ATLAS project	Electrical schematics of the Cu/Polyimide barrel hybrid version 4		
ATLAS Project Document No.	Institute Document No.	Created: <b>12/07/00</b>	Page: 1 of 4
ATL-xx-xx-xxxx		Modified: dd/mm/yy	Rev. No.: A

Project breakdown name			
Electrical schematics of the Cu/Polyimide barrel hybrid version 4			
abstract			
Prepared by:	Checked by:	Approved by:	
Y. Unno, T. Kohriki, T. Kondo, KEK	Blockbold	Blockbold	
SCT	Distribution List

History of Changes			
Rev. No.	Date	Pages	Description of changes
А	12/07/00	All	First version

# 1 Introduction

#### 3.3 Option for connecting ID4 to either SELECT or VDD

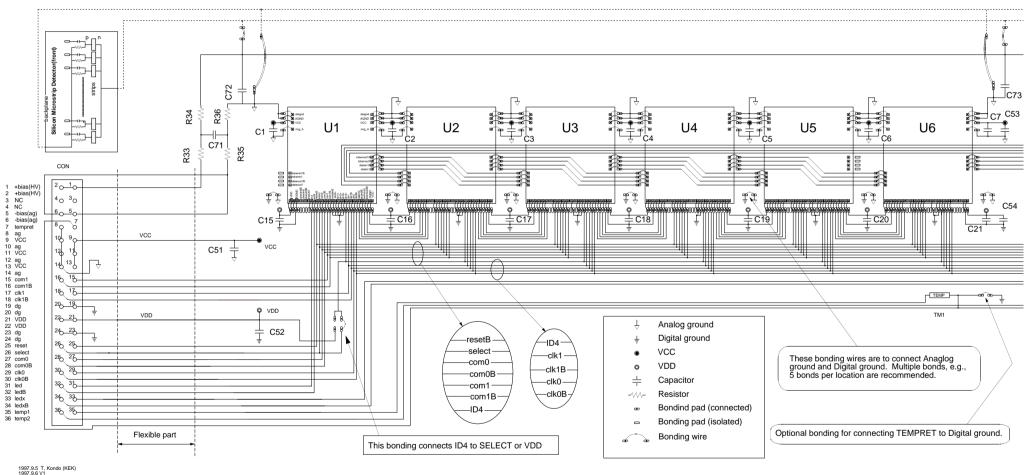
ID4 has a pull-down resistor inside the ABCD chip and the module is served by primary fibre. In case the module is required to be served by an adjacent fibre, the ID4 is set by SELECT-high. An option is requested to set the ID4 high without SELECT-high connection.

Change is

A VDD wire-bonding pad is provided next to the SELECT line pad.
